PLANT NAME: KEWAUNEE

Docket No. 50-305
Operating License DPR-43
Spent Fuel Pool Modifications

RESPONSE TO QUESTIONS IN LETTER DATED 1/30/78

SKETCH 1-1

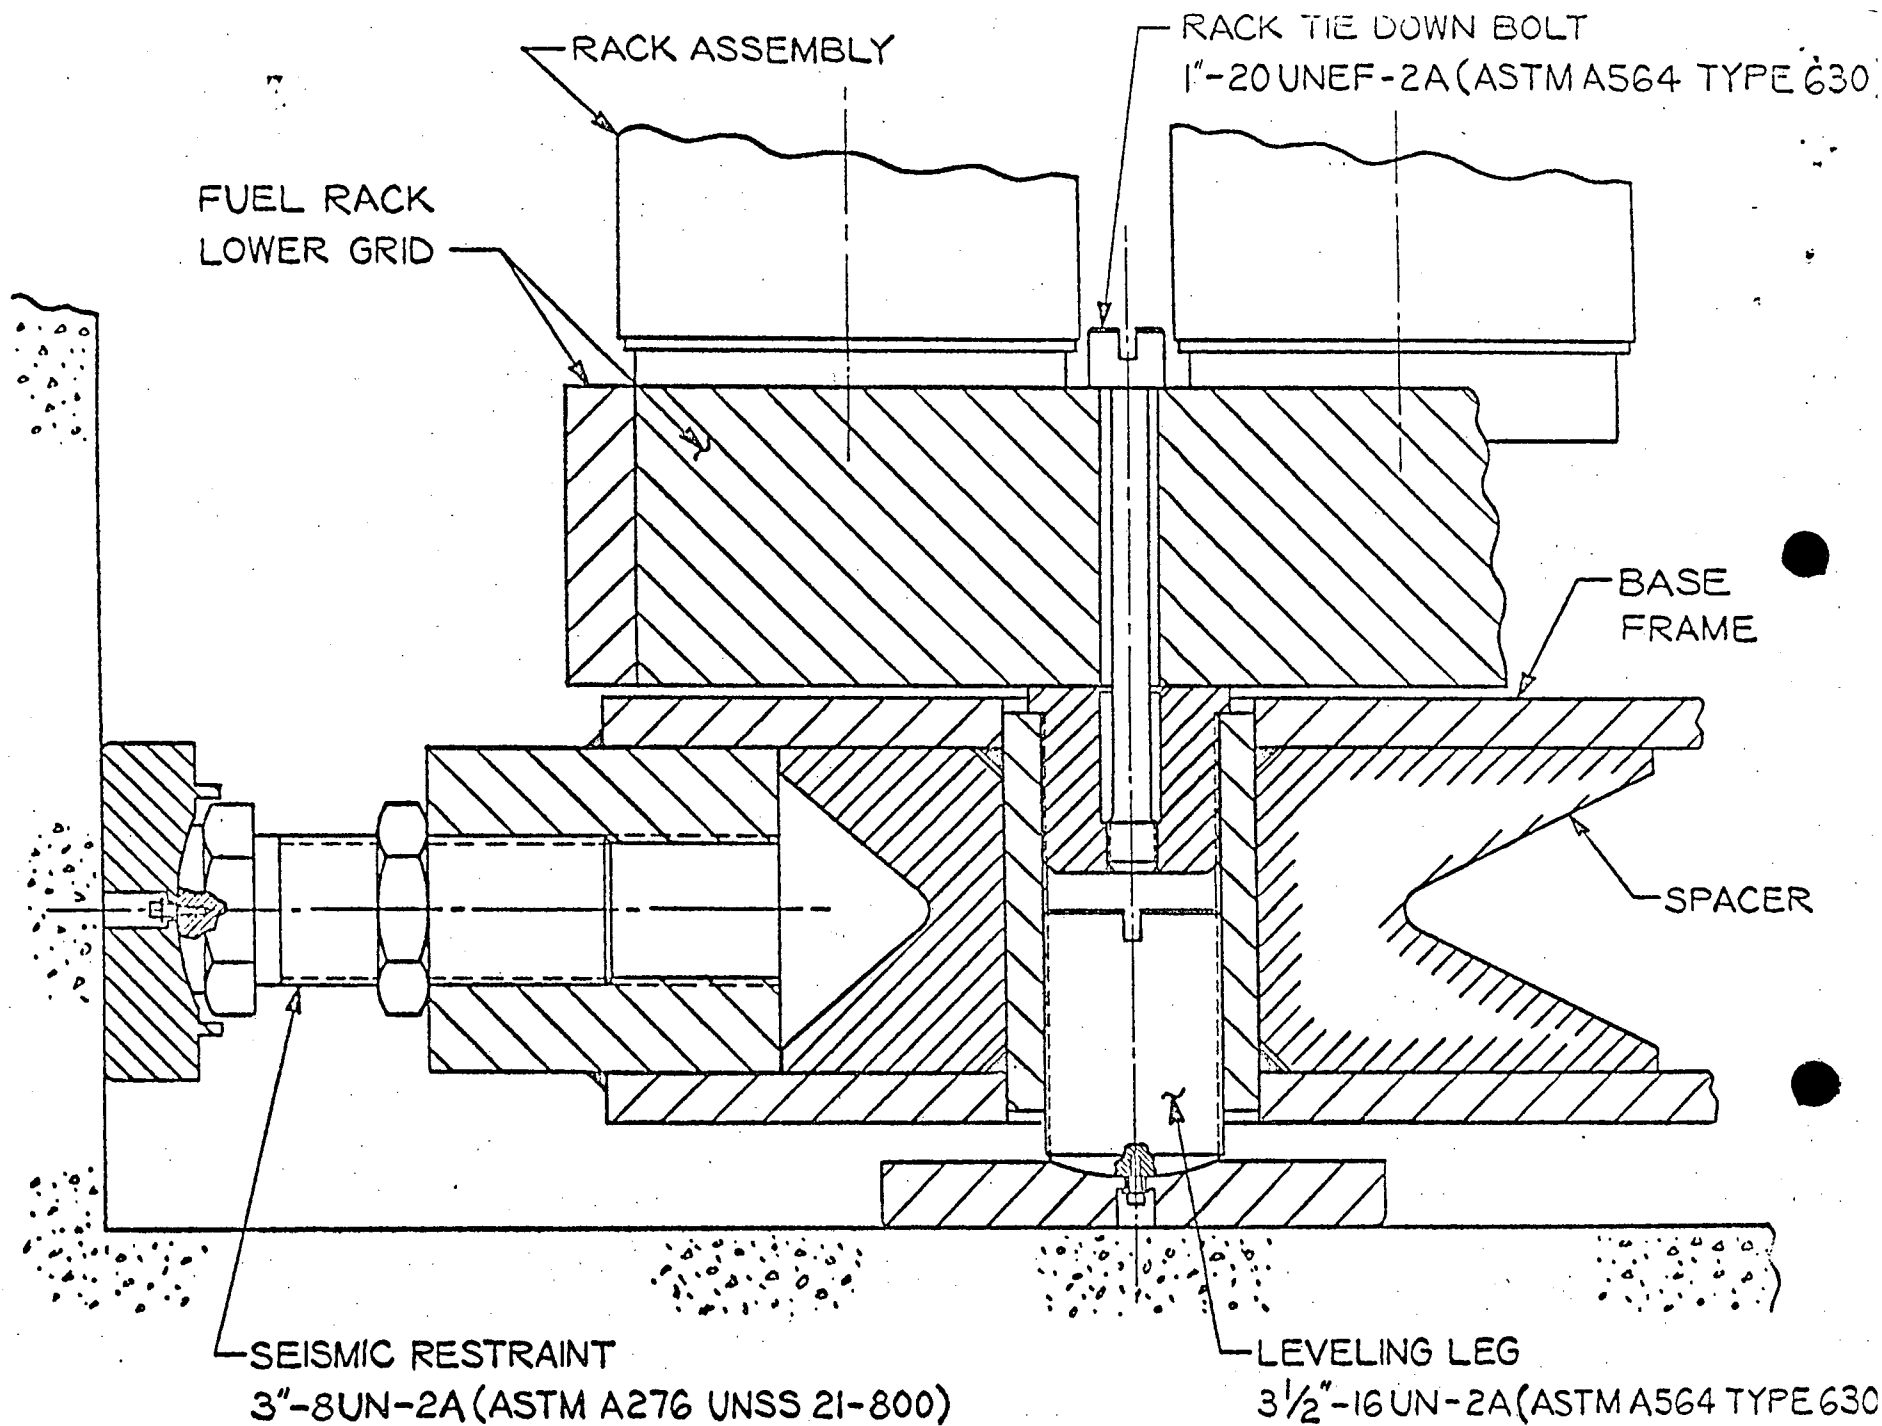
QUESTION NO. 1 Provide detailed sketches of the supports and bearing pads for the individual cans in the fuel rack assemblies. In addition, since Figures 3-1 and 3-2 do not show sufficient details of the rack base structure, provide clear sketches of a typical base and its interconnecting structure to other bases and to the pool walls.

RESPONSE The two attached sketches (1-1 and 1-2) provide the information requested noting that the individual cans are formed into 9 x 10 racks by welding to upper and lower grid structures and the racks are in turn bolted to the base frames which are bolted together to entirely fill the pool and are restrained from moving by "compression only" seismic restraints to the pool walls.

DETAIL OF ① FUEL RACK TO BASE FRAME CONNECTION,
② BASE FRAME LEVELING LEG AND
③ BASE FRAME SEISMIC RESTRAINT

**RESTRICTED
CRANE TRAVEL
AREA**

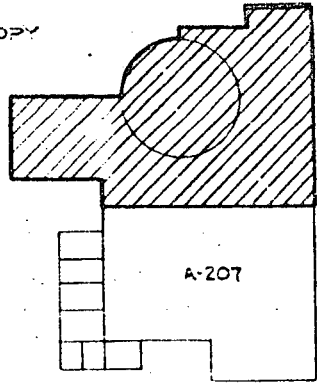
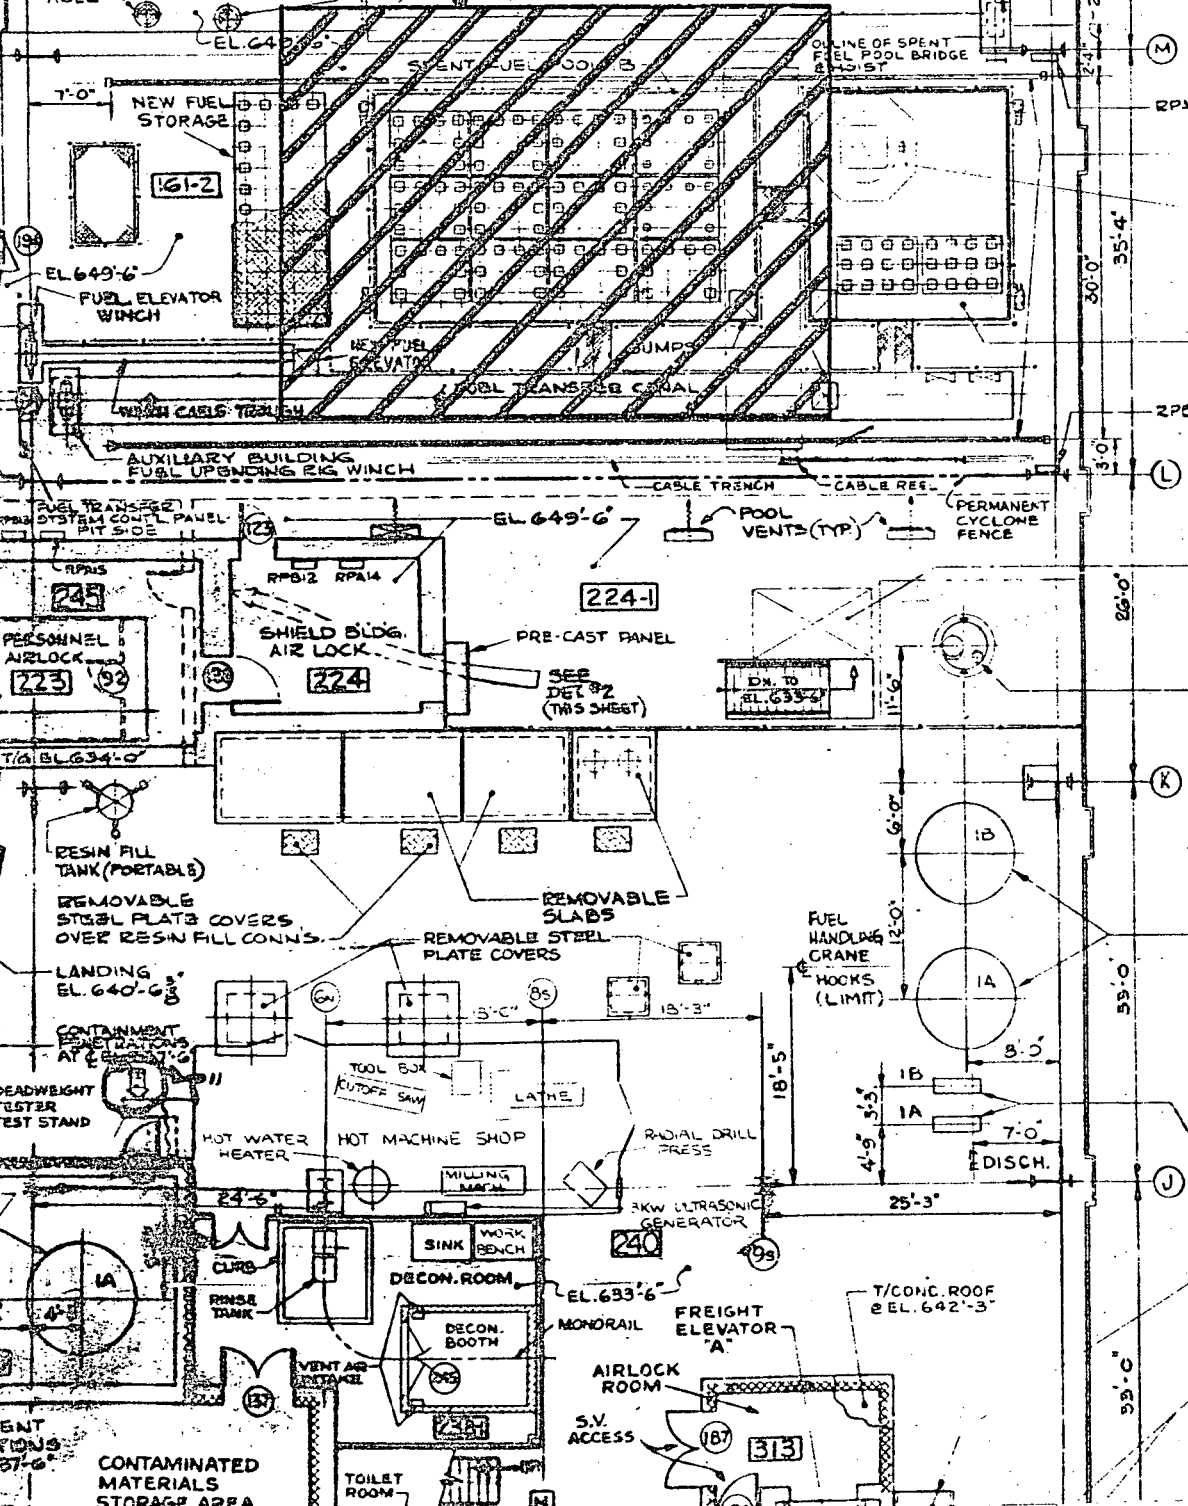
Provide a list of representative loads that might be allowed near or over the spent fuel pool. Provide the gross weight and dimensions (height and horizontal area) of each of these loads as rigged and suspended. Discuss the load transit paths, including which of these loads must be carried over the pool, the maximum height at which they could be carried and the expected heights during transfer. Provide a description of any written procedures instructing crane operators about loads allowed to be carried near or over the pool. Provide the number of spent fuel assemblies that could be damaged by dropping each representative load carried over the pool.

Proposed Amendment No. 31 to the Kewaunee Technical Specifications states "Heavy loads greater than the weight of a fuel assembly will not be transported over or placed in either spent fuel pool when spent fuel is stored in that pool. Placement of additional fuel storage racks is permitted, however, these racks may not traverse directly above spent fuel stored in the pools".

The attached sketch depicts existing crane corridor and restricted areas of travel.
